# Validation Report

## Validation of the AWMS Methane Recovery Project BR06- S -20, Minas Gerais, Brazil

**Report No. 842817, rev. 1**

**Annex 3: Pictures and drawings evidencing the distance between Granja Itajuba (PDD 25) and Granja Sao Francisco (PDD 20)**

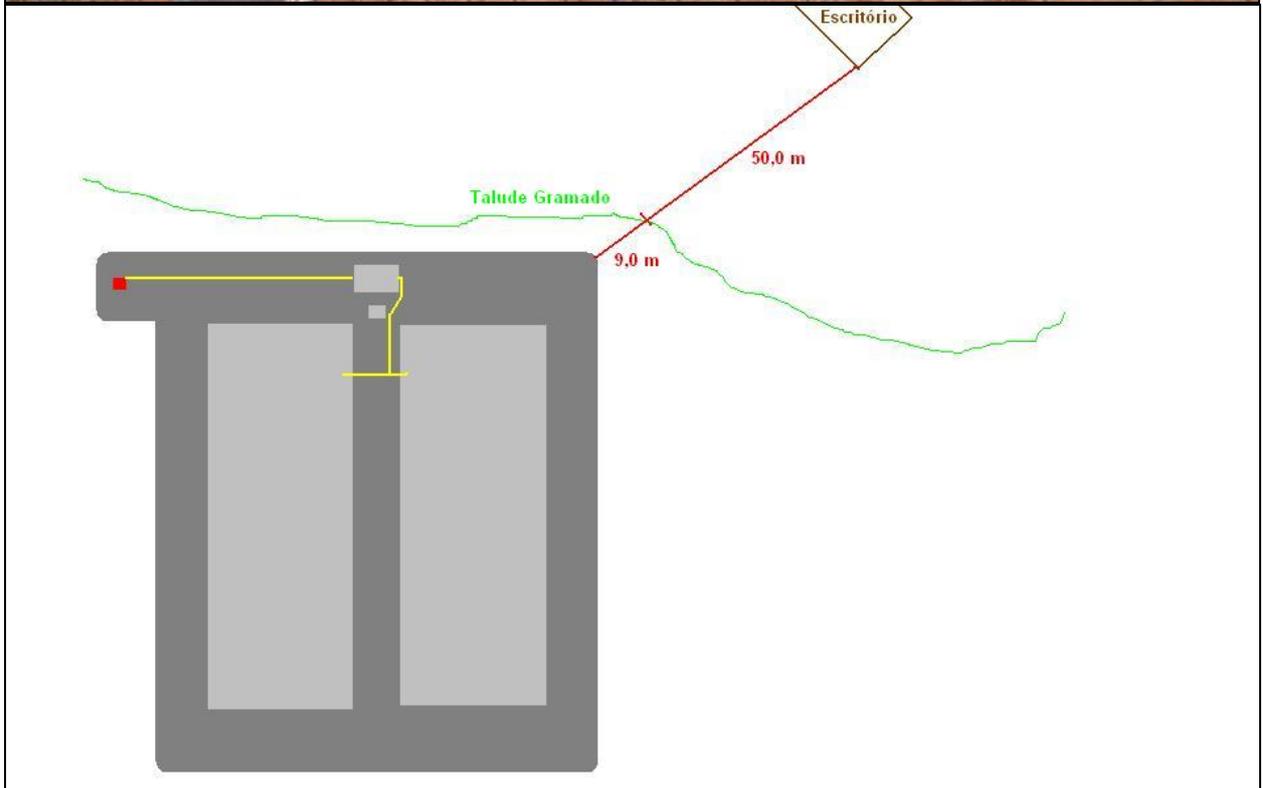
It has been identified one critical case for debundling. The farm “Granja Sao Franscisco” is situated very close to farm “Granja Itajuba” from project BR 06-S-25. AgCert has to provide a very precise GPS data from the biodigestors of the farms and hence to evidence that the two biodigestors are situated more than 1 km from each other.

Farm Granja Itajuba (PDD 25) and farm Granja Sao Francisco of PDD 20 are proven to be more than 1 km apart, according to GPS coordinates taken from the farm, and the distance between the points where those coordinates were taken and the precise location were biodigesters are planned to be built. Evidences are in annex 3 (pictures and drawings).
